Transmission Line 637
San Diego Gas and Electric
“The Witch Fire 2007”
“The Cedar Fire 2003”

Presented by:
Ed Clark
The Electrical Expert
<http://www.TheElectricalExpert.com>

HOW DID IT HAPPEN?
Is there a link that started them all?

DOWN GUY CONSTRUCTION

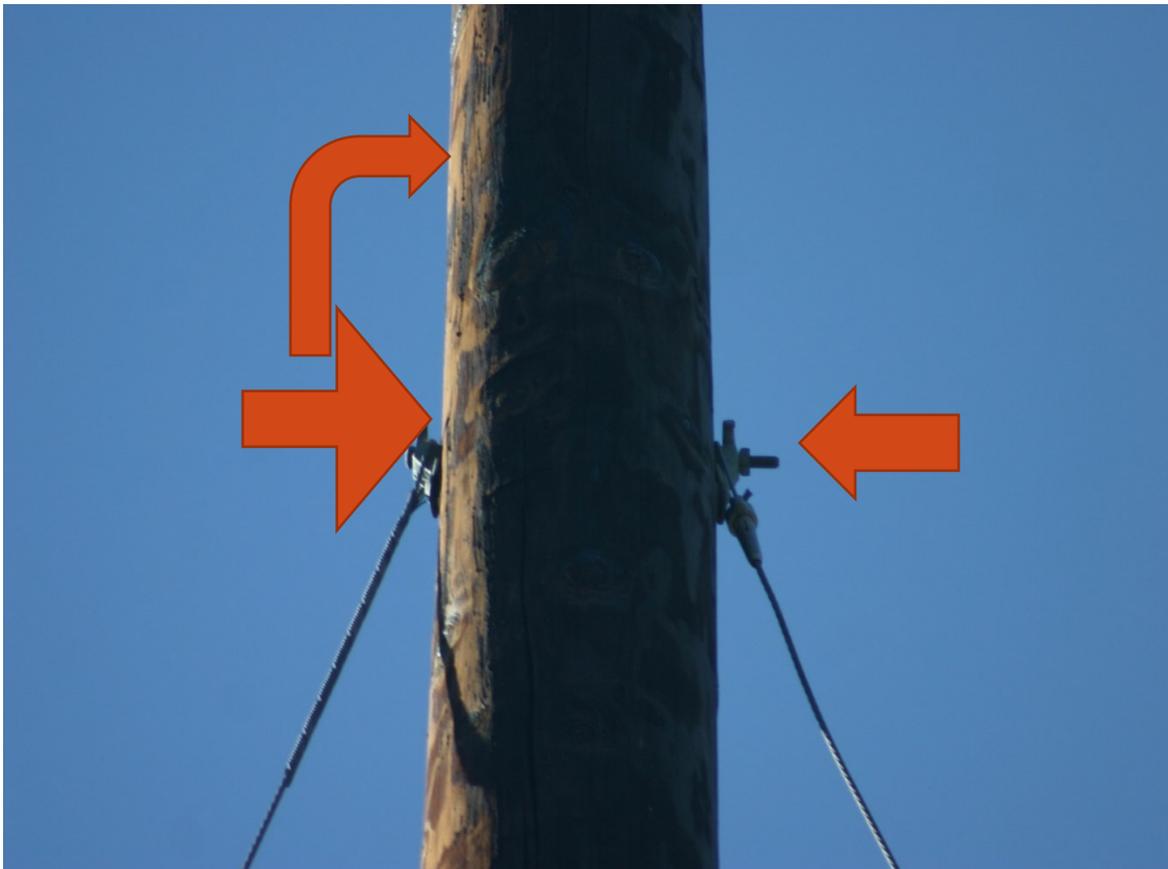
**1. Attached at same location on pole
“WRONG”**

**2. Insulators not utilized!
“WRONG”**

Down Guys Attached at the Same Point :
“WRONG”

**“ Must have
12 inches
Vertical
Clearance or
use
Insulators”**

Ground rods found at various locations??

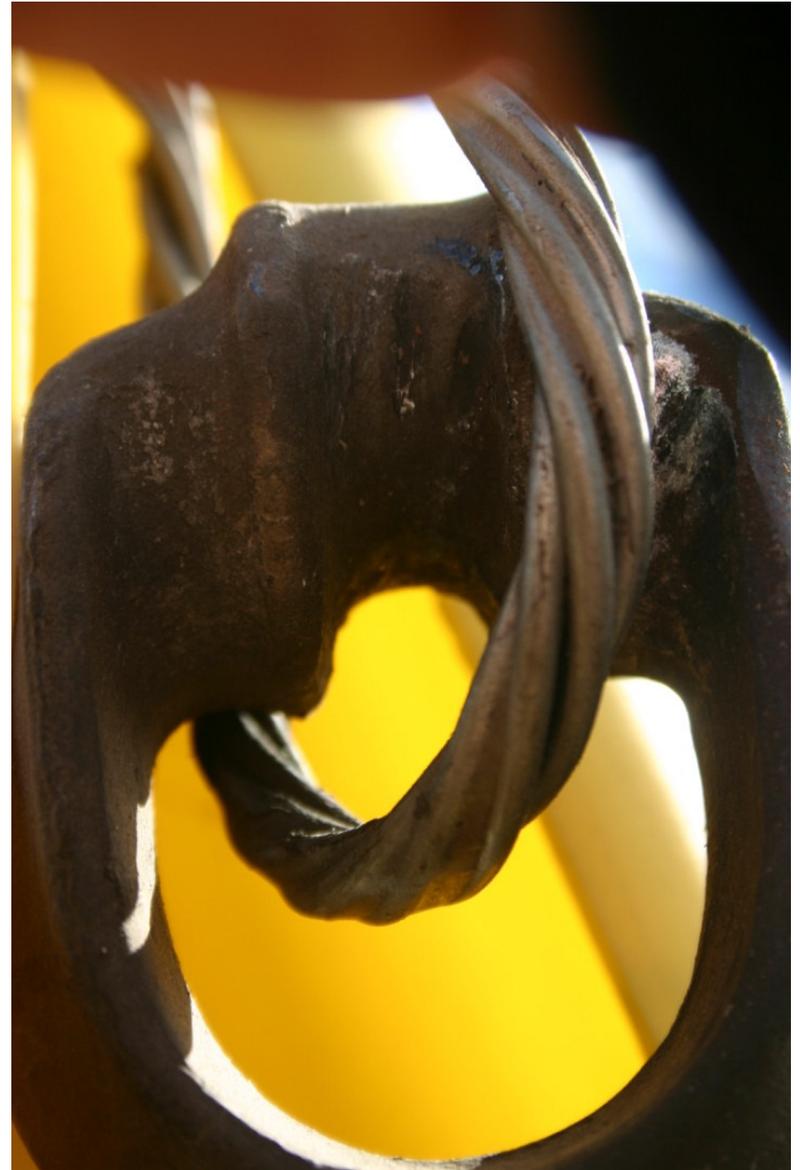
Same down guy construction attached at the same point without vertical clearance or the use of insulators, multiple locations.
